**Proposed Residential Development (Flat) with Shop and Services Use
 and Minor Relaxation of Plot Ratio and Building Height Restrictions
 at Lots 531 RP, 532 S.D. RP and 532 RP in DD 130 and
 the adjoining Government Land, Lam Tei, Tuen Mun
 (Planning Application No. A/TM-LTY/502)**

- Further Information No. 3 -

Response-to-Comment Table

Figure 5.1 from Landscape Drawings

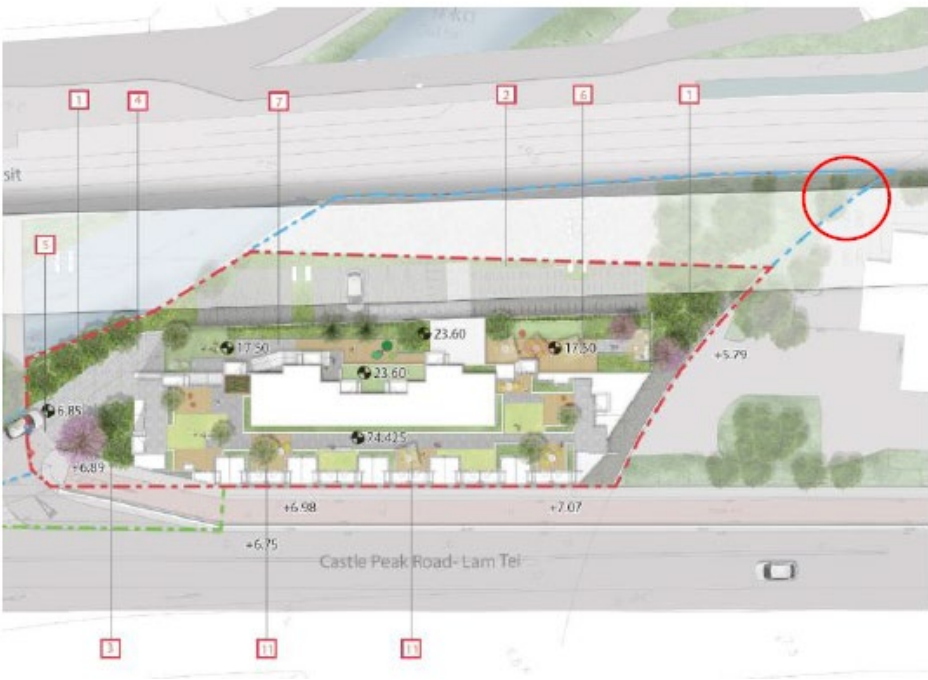
<p>1. Figure 5.1: noted some trees are placed on the northwestern corner beyond the Development Boundary but within the Application Boundary (circled in red in the figure below). As noted from the submitted Tree Recommendation Plan (Annex V to the Tree Preservation Proposal) on 9.12.2025, no existing or proposed trees are located in that location. Please clarify if any landscape treatment/tree planting will be proposed at that portion.</p>	<p>Figure 5.1 has been updated to be consistent with Tree Preservation Proposal (<i>Appendix IV</i> refers).</p>
